STAFF REPORT
COMMUNITY DEVELOPMENT DEPARTMENT

DATE: 4/9/2024
TO: City Council
FROM: Sonya Allen, Associate Planner
208-884-5533
SUBJECT: Millwood Subdivision
[FP-2023-0011](#)
PROPERTY LOCATION:
1975 E. Victory Rd., in the NW 1/4 of
Section 29, T.3N., R.1E. (Parcel
#S1129223095)

Final plat consisting of 17 building lots and two (2) common lots on 4.11-acres of land in the R-8 zoning district.

B. Final Plat (dated: 4/3/2024)

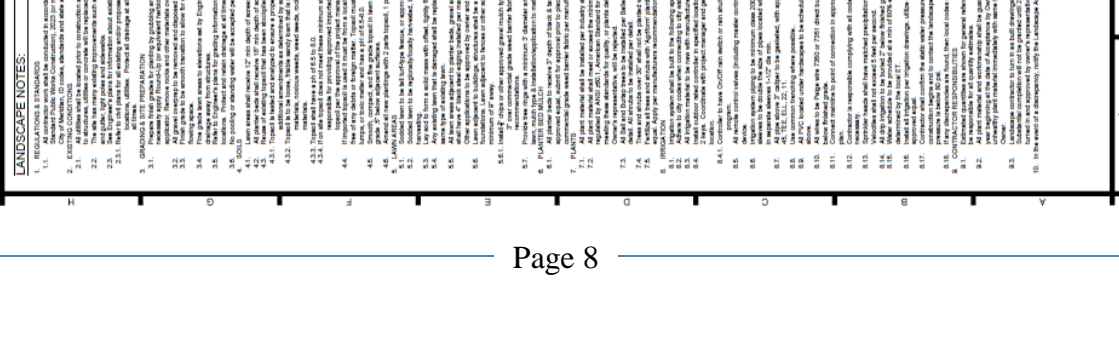
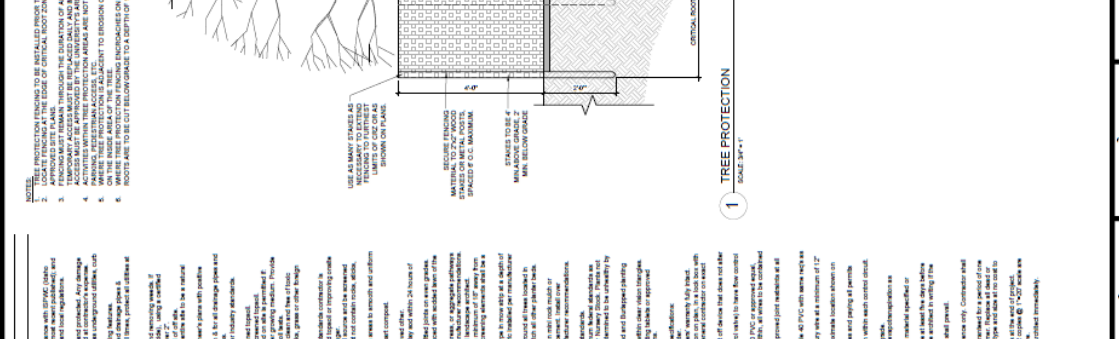
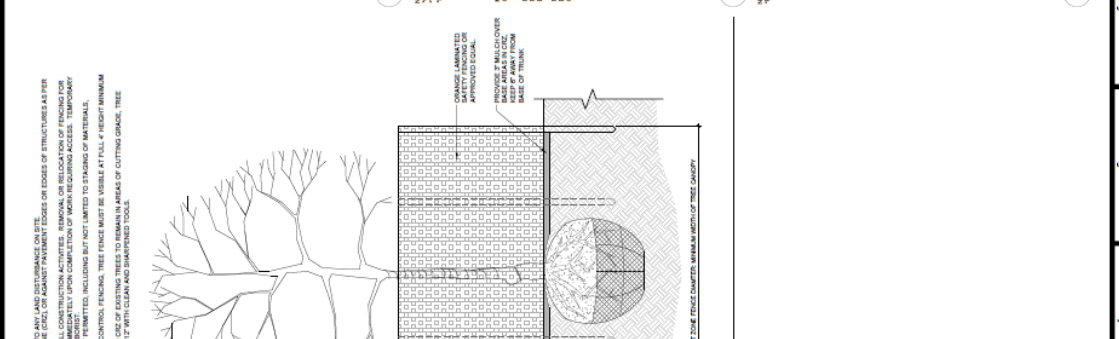
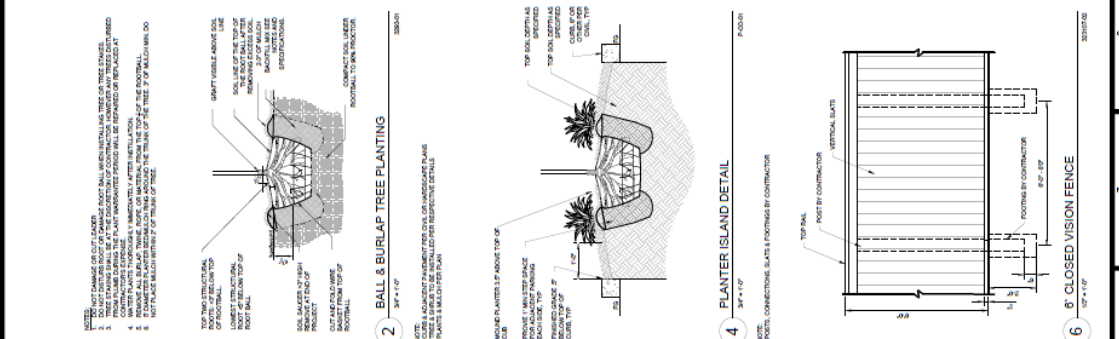
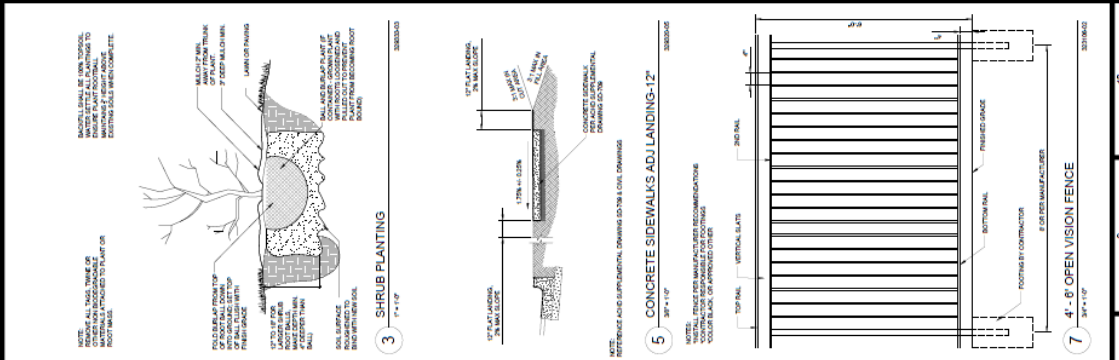
3. Prior to submittal for the City Engineer's signature, have the Certificate of Owners and the accompanying acknowledgement signed and notarized.
4. The final plat, signed and stamped by Eric Howard on 1/29/24, included in Section V.B, shall be revised prior to submittal of the final plat for City Engineer signature, as follows:

- a. Update the year of platting in the situate statement.
 - b. Include a curve table.
 - c. A perpetual ingress/egress is required for the common driveways on Lot 1, Block 1 and Lot 6, Block 2, either by a recorded easement or as a note on a recorded final plat. The easement or plat note shall include a requirement for maintenance of a paved surface capable of supporting fire vehicles and equipment in accord with UDC [11-6C-3D.8](#).

E. Site Plan

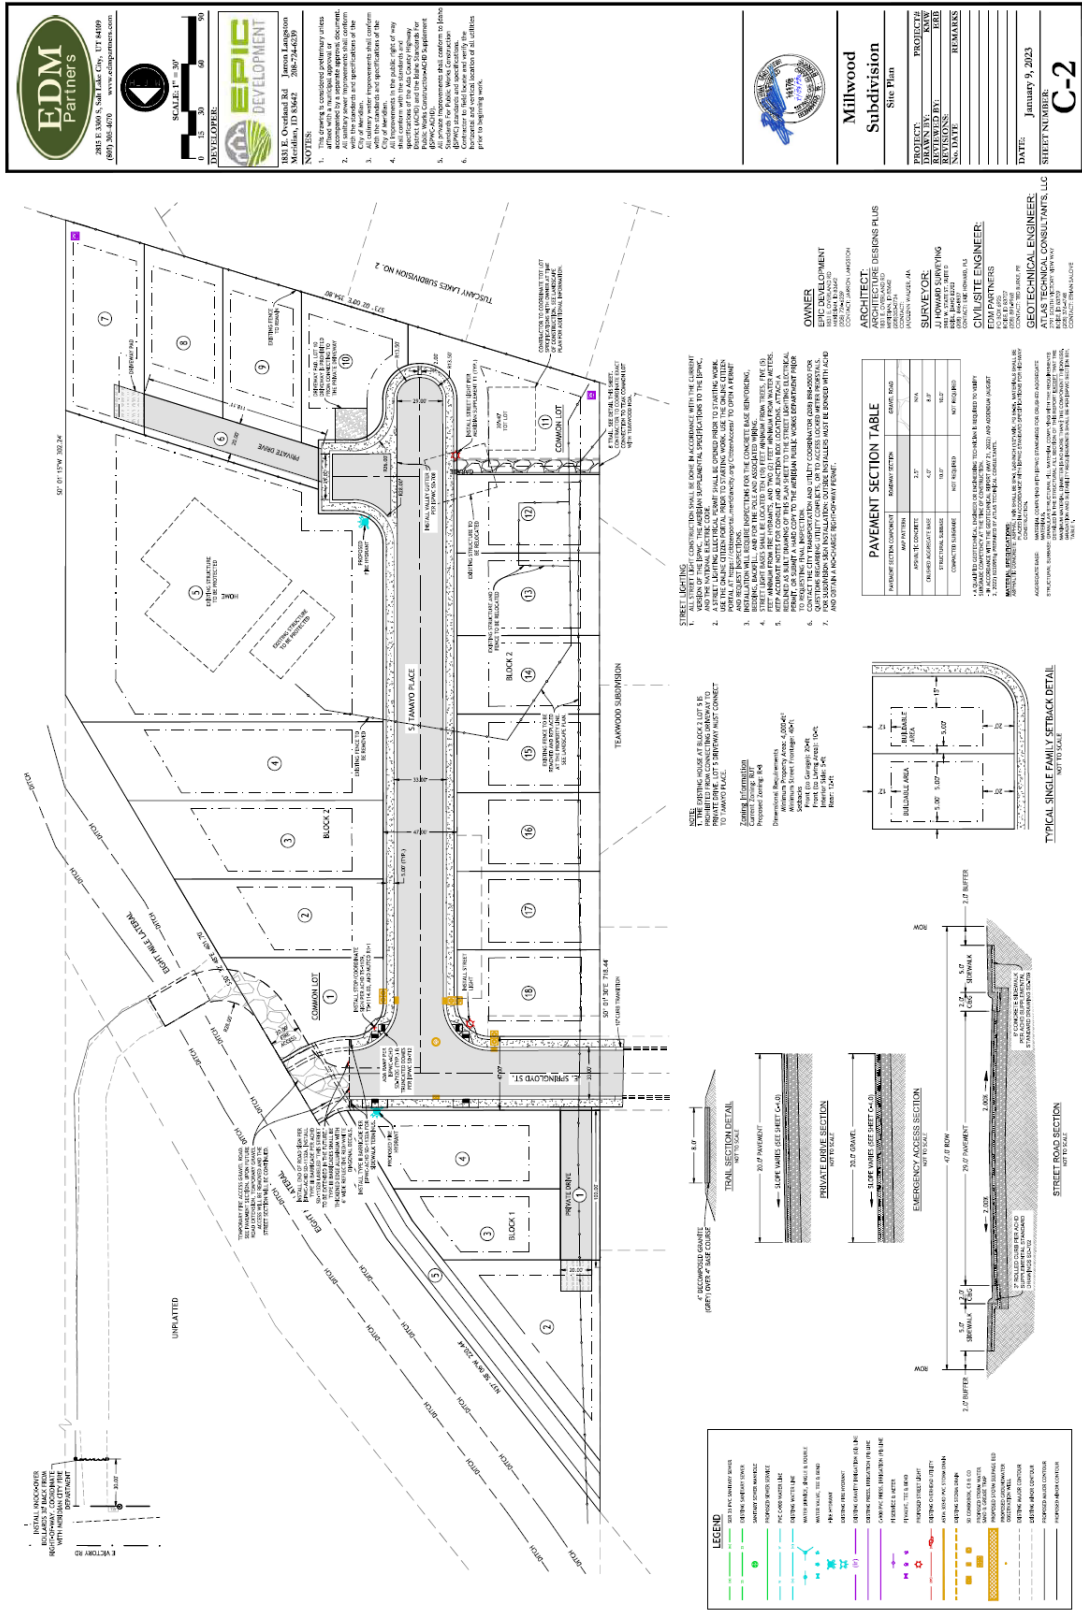
5. The landscape plan prepared by Stack Rock Group, dated 12/12/23 included in Section V.C, shall be revised prior to submittal of the final plat for City Engineer signature, as follows:

- a. Depict landscaping (i.e. shrubs, lawn or other vegetative groundcover) within the 5-foot wide strips along the common driveways on Lot 1, Block 1 and Lot 6, Block 2 in accord with UDC 11-6C-3D.5. Also, depict fencing along the common driveways if proposed.

- b. Depict 5-foot wide landscape strips on each side of the 10-foot wide multi-use pathway on Lot 5, Block 1, landscaped per the standards listed in UDC [11-3B-12C](#) per preliminary plat condition #3c.

- c. Include mitigation calculations on the plan for existing trees that are proposed to be removed in accord with the standards listed in UDC [11-3B-10C.5](#).

- d. Include calculations that demonstrate compliance with the pathway landscape standards listed in UDC [11-3B-12C](#).
 - e. Include a detail for each of the proposed fencing types and for the children's play equipment proposed for the tot lot.

- f. Remove the perimeter fencing along the west boundary of the common lot at the southwest corner of the development where it adjoins common area in Teakwood Subdivision *if* the Applicant is able to coordinate with the adjacent developer to arrange no fencing on that development in the same area.

- g. Depict a 6-foot tall open vision fence (wrought iron) fence between the pathway and the lateral for public safety in accord with preliminary plat condition #3j.

- h. Depict landscaping within the storm drainage area on Lot 1, Block 2 in accord with the standards listed in UDC [11-3B-11C](#); also depict slopes less than or equal to 3:1 for accessibility and maintenance.

- i. Relocate the fencing depicted on the south side of the pathway on Lot 11, Block 2 to the northern boundary of the lot and provide a minimum 5-foot wide landscaped strip between the property line and the pathway with landscaping per the standards listed in UDC [11-3B-12C](#).

G. Emergency Access Exhibit (Approved by Fire Dept.)

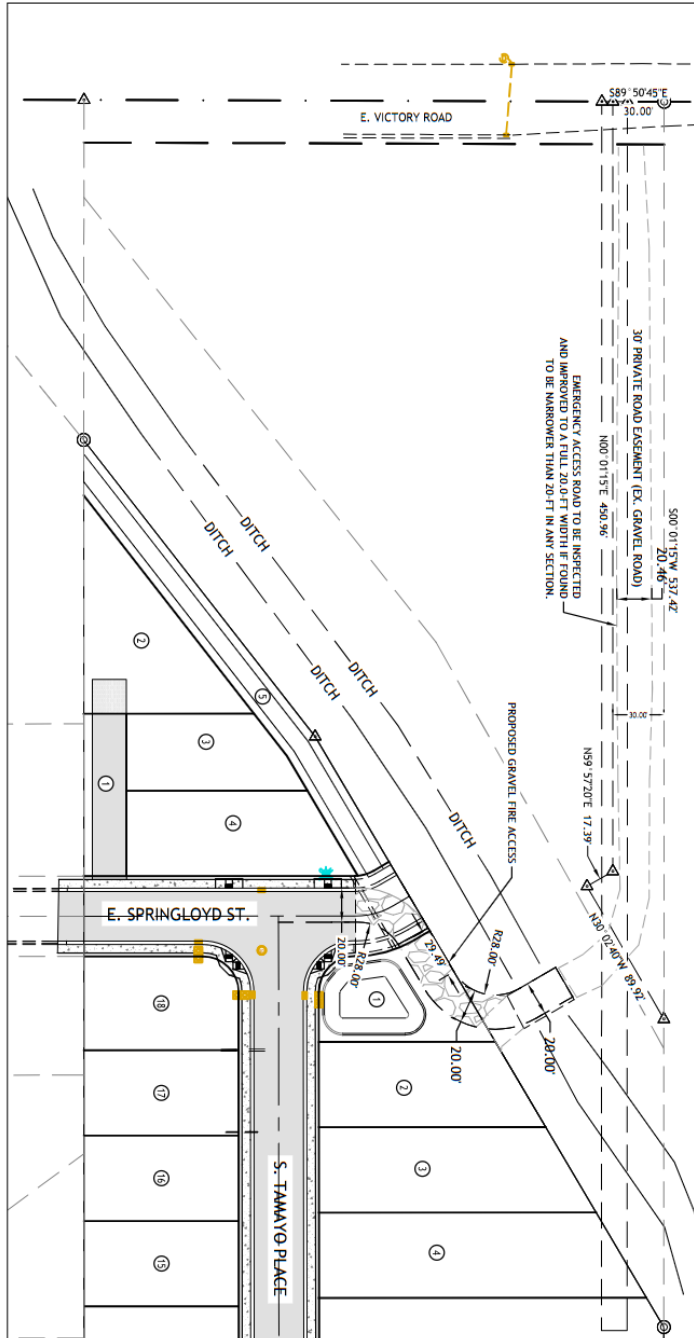
11. The common driveways on Lot 1, Block 1 and Lot 6, Block 2 shall comply with the standards listed in UDC 11-6C-3D and the exhibit in Section V.D. The driveways shall be paved with a surface with the capability of supporting fire vehicles and equipment.
